MAAN NO:1877

TITLE: Microlight Airworthiness Approval Note 1877, Shadow D, DD and D-SS aircraft, resolution of pitch circuit resonance (elevator flutter) concerns.

Title: Implementation of a new elevator friction device.

Reference: SB MAAN 1877/2 issue 1
(Appendix A to MAAN 1877 issue 2)

Figure 4, Re-fitted teleflex attachment with damper in place

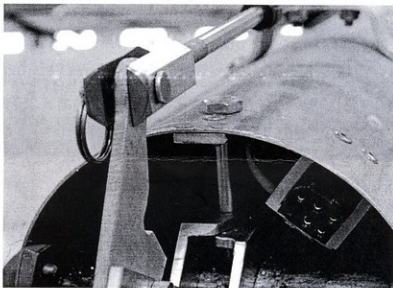
- (I) Refit the elevator, taking care to reconnect QTY4 elevator hinge pins (including their safety pins), then re-attach the elevator Teleflex attachment and clevis ring (see Figure 4 below).

Figure 5, Matched up arms, drilled with first screw in place

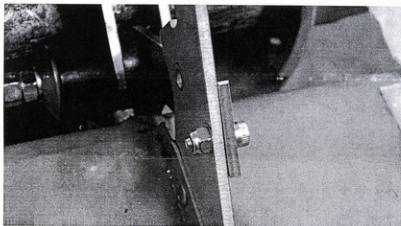
- (J) Place a G-clamp (or similar temporary clamping device) across the lower elevator damper arms and the elevator arm so that they are rigidly flush with each other, with the edges flush. **IMPORTANT:** Take care to ensure that the clamp jaw is covered with card, etc. to avoid scoring the aluminium alloy surface.
- (K) At the upper side there will be two holes drilled in the elevator damper arm. Ensuring that this arm and the elevator control horn are flush against each other by putting a small G-clamp (or similar) over the other hole drill through each hole with a 4mm HSS twist drill. After drilling the first hole carefully debur then fit the supplied caphead (Allen) screw and self locking nut. Tighten, then drill and debur second hole before fitting the screw to that hole. (Figure 5 below.)

Figure 7, Making adjustments to the damper mechanism,

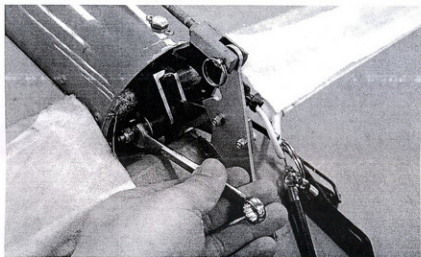
- (N) Now adjust the friction on the device using a 10mm open-end spanner and Allen key (see photo) so that with the elevator horizontal, you need 2.5 - 2.6 kg [5.5 - 5.7 lbf] of pull upwards (at the trailing edge of the elevator centreline, next to the trim tab hinge) to move the elevator. After the correct adjustment is found tighten the 6mm nylock locking nut against the aduster nut to secure. (Figure 7 below.)

N. Beale	M. Broome	MAAN 1877	JUNE 2005
Inspection Date		Scale	NTS
21-6-05			
Elevator Damper Assembly			
Issue No		Issue No	Sheet
Initial		Initial	ONE

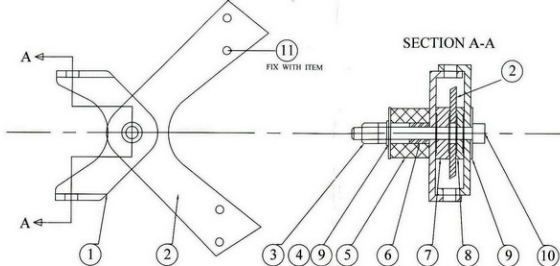
BMAA Major modification No. 1877 is approved, consisting of an elevator pitch damper for fitment to CFM Shadow D, DD and D-SS aircraft.
